Response to Submissions for the Amended Proposal

Western Sydney University Indigenous Centre of Excellence

SSD-64916225

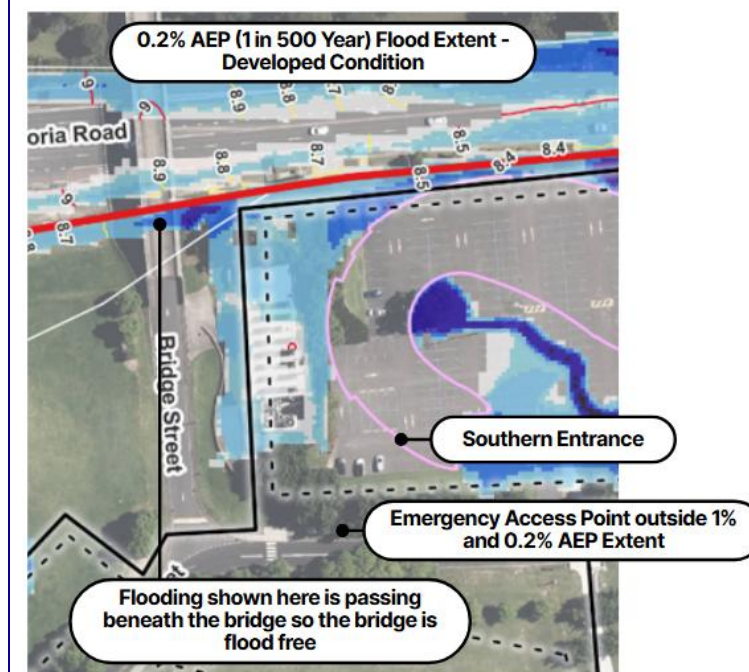
Principle 4 Decisions on development within the floodplain does not increase risk to life from flooding.	NSW SES	The isolation period is less than 1 and a half hours in a PMF and only marginally longer (2 to 2.5 hours based on the Victoria Rd sag) in a 1%

Managing flood risks associated with Low Flood Islands requires careful consideration of development type, likely users, and their ability respond to minimise their risks. The site is considered a low flood island, as the definition of a low flood island is where “the roads can be cut by floodwater, closing all the evacuation routes and creating and island” and “the flood island is lower than the limit of flooding” (i.e. lower than the PMF).

The statement that “Even in a PMF event, emergency access to and from the site can be achieved via the Bridge St overpass” does not consider that there would be no flood-free access to the building, nor does it consider that this strategy relies on the stability of a bridge which would be exposed to H5 hazard floodwater.

Figure 41: Peak Flood Levels and Depths – 1% AEP (with additional 19% rainfall loading)– Developed Condition

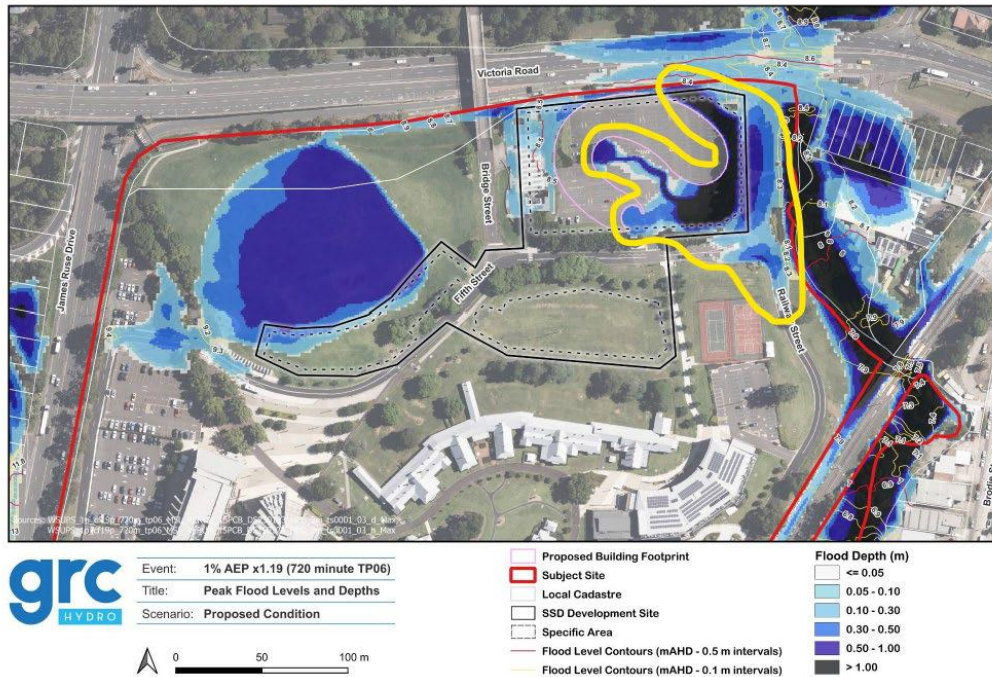
Flooding – City of Parramatta		
<u>Flood modelling requirements</u> Rainfall Intensity and Temporal Pattern: The 19% increase in rainfall intensity (with the highest temporal pattern) appears to have only been used in sensitivity analysis. This increment and temporal pattern should be included in the base case/design case for all design, flood impact assessment, and flood planning level calculations as this allowance is for Flood Frequency Analysis calibration and is adopted.	COP	GRC has modelled this scenario and included results and impacts within their report. Other agencies such as CPHR and SES, have requested that the 1% AEP with scaling in alignment with what ARR considers as 'present-day climate change.' This is approximately equivalent to an 11% rainfall in increase on top of the 1% AEP event. This has been adopted as the compliance event in keeping with agency requests.
Hydraulic Consistency: Confirm that upstream flows at Victoria Road bridge match the adopted Parramatta River Flood Study.	COP	GRC's modelling has been adopted at the site as the PRFS model was found to be unsuitable. GRC's previous reporting has documented the verification of the model.

Flood Storage: Any loss of flood storage (up to 1%FFA AEP, adjusted for the 19% rainfall increment) must be compensated. Provide cross-sections and volume calculations to demonstrate compliance.	COP	Previous versions of works preserved all storage by retaining an open undercroft area. However, based on Councils preference the works are now slab on ground. This does involve 2,200m³ of flood storage being lost on the site (which is approximately 0.5% of total event volume in the defined event). Despite this minor loss of flood storage at the terminal end of the catchment, the detailed impact assessment carried out indicates no downstream or upstream impact. For loss of storage, under standard hydrological theory any impact would be in the downstream. As per GRC's impact mapping reported there is no impact.
Flood Depths: The post-development scenario shows flood depths >1m (highlighted in yellow). Explain how this will be managed. If this area is a detention basin, provide design and safety details and confirm if it triggers Dam Safety NSW requirements.	COP	This area is not a detention basin. It is only temporarily inundated in rare storm events and it will be drained by a pipe that connects with the existing stormwater infrastructure that drains to Vineyard Creek.

Figure 36: Flood Level Impact – 1% AEP – Developed Condition Minus Existing Condition

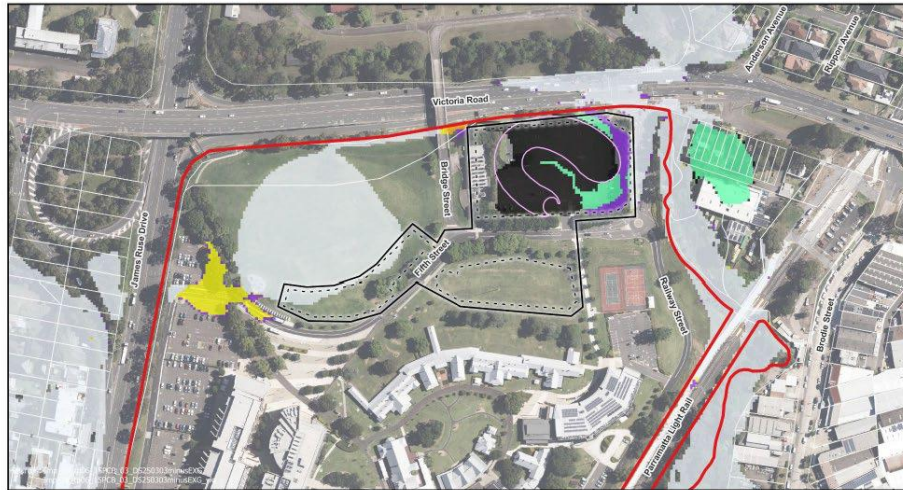
- Clarify if the assessment includes the 1%AEP + 19% rainfall increment with highest TP.
- Removing flood storage is unlikely to have no impact—provide evidence.
- Address the cause of the 10–100 mm flood afflux on the western side; ensure no worsening of existing flooding.

The assessment using the 19% factor is presented in Figures 23-24, 48-50 of GRC's report. However, the Defined Flood Event for the purpose of GRC's reporting is the 1% AEP with present day climate change.

Detailed impact assessment has been carried out. For loss of storage, under standard hydrological theory and impact would be in the

Figure 8 Figure demonstrating proposed entry points and activated facades of the building.

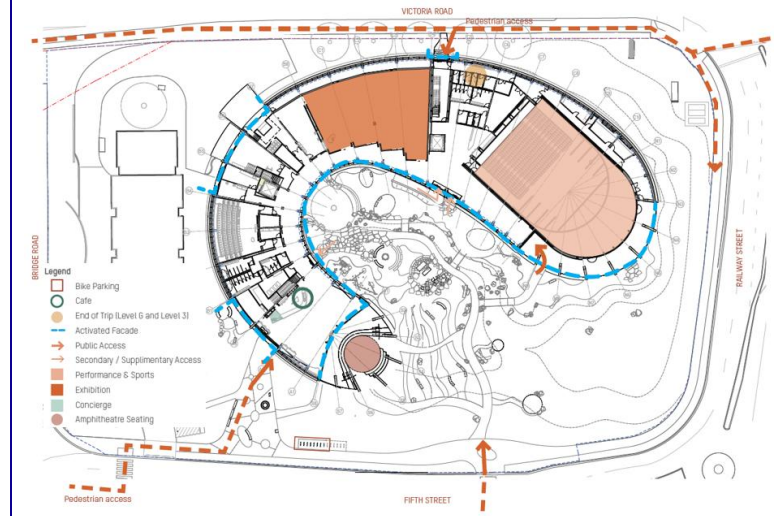
Figure 9 Likely future view of the site as viewed from the Victoria Road, road reserve looking southwest towards the site. Source: Virtual Ideas.
Further design consideration is still recommended to reduce the building's perceived bulk and scale through modulation and articulation, while maintaining the intended continuity through the use of a singular material.	COP	The proposed design has evolved with consideration to connectivity within the campus and internal pedestrian activation, as well as the site's key parameters including the retention and significance of the Melaleuca tree and Vineyard Creek. The building is oriented to provide an extension of the ecology of the creek and frame the Melaleuca tree which is proposed to be retained. The buildings' design has continued to evolve and has reduced in scale from four (4) storeys to three (3) storeys, and the rooftop net enclosure has been deleted. The buildings' modulation has been further refined as shown through the north tip of the structure being elevated to encompass the volume of the theatre and multi-purpose court, while the southern end is gently lowered while retaining a triple-height entrance void, facilitating natural way finding between large civic spaces and smaller, intimate areas. Further, the entire mass of the building tapers inward, giving the Melaleuca tree ample space to thrive and offering expansive views towards the sky. This tapering also serves structural purposes by reducing the required depths of structural elements and providing articulation to the overall built form.

A more refined signage zone that occupies less of the façade is recommended to ensure the material and architectural expression remain prominent.	COP	The proposed signage zone facing the Victoria Road frontage will provide an area for image projection onto the building zone. Given the signage zone will consist of a light projection, the material and architectural expression of the building will still remain prominent and will not alter the built form. The objectives of the signage zone are to: Enhance the nighttime presence of the ICoE and be a visual draw to the building and act as a visual gateway to the university.

The buildings' formal entry points to the ICOE are located on the southern elevation of the building with direct access from the Elders carpark and pedestrian links from the campus. Activation of the ground plane is facilitated through various building functions and arrangement of outdoor and landscape areas. Supplementary entries to the building, such as the one on Victoria Road, provide important activation along the building's perimeter (refer to Figure 8).

Another key feature of the building's design is its singular façade system, which is optimised to different site conditions and orientations. The façade has two functions: a 'quiet façade' to the

central landscape that allows permeability and multi-sensory connections to the outdoor environment, and a 'protective façade' that buffers noise and air pollution from the central energy plant and Victoria Road to the north and west.

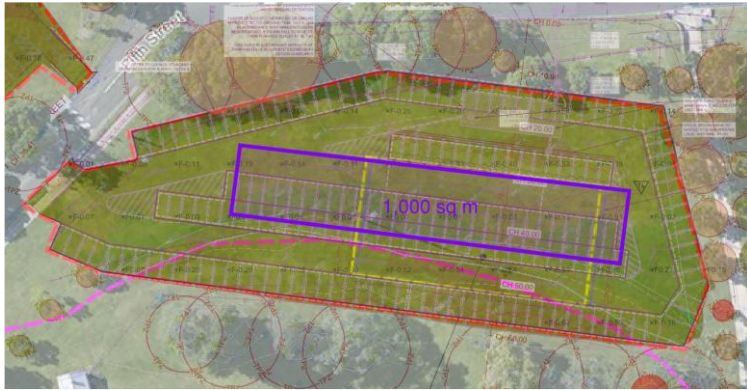
b. Further assessment of the proposed borrow pits, noting that these works are likely to result in a requirement for additional excavation.	Heritage NSW	It is acknowledged that the original proposed location of the borrow pit in the eastern car park area had potential to intersect with the predicted alignment of the former ha-ha wall. Following further internal review and consideration of the archaeological constraints identified in the HAA the design team has revised the location of the borrow pit to minimise potential ground disturbance within areas of archaeological sensitivity. The revised location now avoids the area of the eastern car park where the ha-ha wall may have been present, based on historical mapping and topographic features. This amendment aims to reduce the likelihood of impacting any subsurface remnants associated with the ha-ha wall. While the potential for survival of structural remains is assessed as low with moderate potential at depth due to historical ground disturbance in the area, the relocation of the borrow pit is an additional heritage mitigation measure to further minimise impact. It is recommended that an archaeologist be present during excavation works to monitor for any potential finds and to implement the Unexpected Finds Protocol. Any findings of potential archaeological significance will require a stop-works protocol, be recorded and reported to Heritage NSW in accordance with the site's heritage management framework.

• The presence of terracing aligned with historical imagery of the ha-ha wall, suggesting potential remnants of the feature may survive beneath current ground level. • The uncertainty about the depth and extent of 1990s earthworks, which may have impacted or preserved buried structural remains depending on methodology and material use. • The exact depth and degree of previous disturbance is unknown due to the lack of detailed records regarding the extent and method of 1990s site regrading, trenching, and service installation. • The topographic expression of two distinct slopes in the eastern car park, which may correspond to the wall and ditch components of the ha-ha. • Analogous findings at Cumberland Hospital, where intact ha-ha remains were found unexpectedly at depth on one side, while entirely removed on the other. The AMBS statement that “remains are more likely to survive at depths below 1–1.5 m” on page 33 is supported by contextual topography and the extent of landscaping fill. However, some wording a few paragraphs later does create some confusion, as they reference survival potential “within the uppermost metre”. <u>Revised Archaeological Potential</u> Structural remains of the ha-ha wall, if present, are most likely to be located at depths from 1–1.5 m below current ground level. The uppermost metre has likely been disturbed to some capacity by late 20th century redevelopment and landscaping.

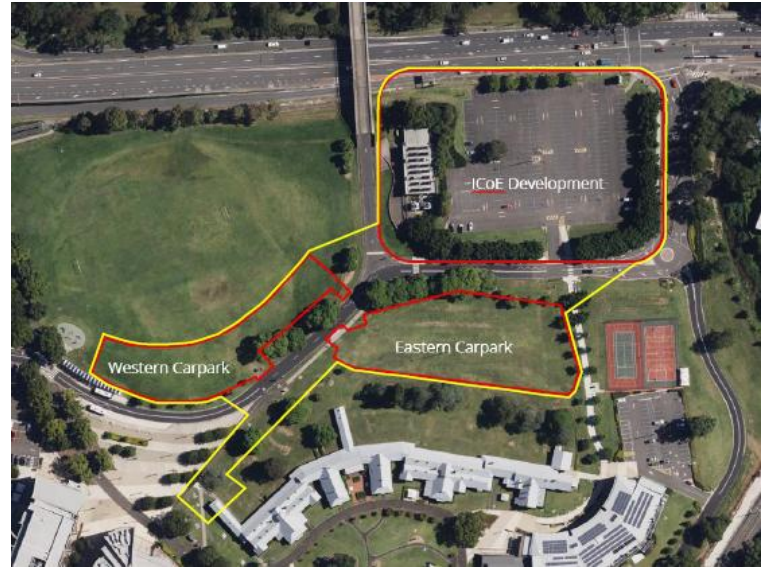
b. Please update the study area boundary on the mapping to include all areas requiring ground disturbance that have been assessed in the revised ACHAR.	Heritage NSW (Aboriginal Cultural Heritage)	Refer to the Figure 11 below, which has also been reproduced within the Curio Heritage RTS Response and illustrates the updated study boundary with red outline representing the development area and the yellow outline representing the extent of all proposed works within the study area boundary.
